**Re: Third Submission Review – Gun Club Data Center – Site Plan & Plat**

Application Number: **DA-2231-04**

Case Numbers: **2021-6004-00**

## Third Submission Review

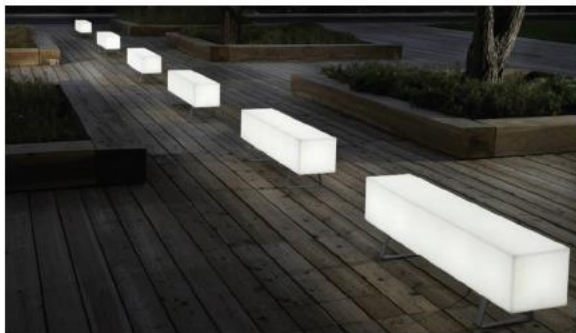
- 2A. Please provide an equal or better level of architectural detailing on the exterior elevations as you have on the interior elevation.
- 2B. The architecture as proposed does not meet the design standards of the Master Plan. The site lies in Planning Area 5, also known as the “Venture” area. This will be discussed in further detail at a meeting scheduled for Monday, June 28, 2021.
- 2C. Site lighting standards should be consistent with the standards illustrated in the master plan.
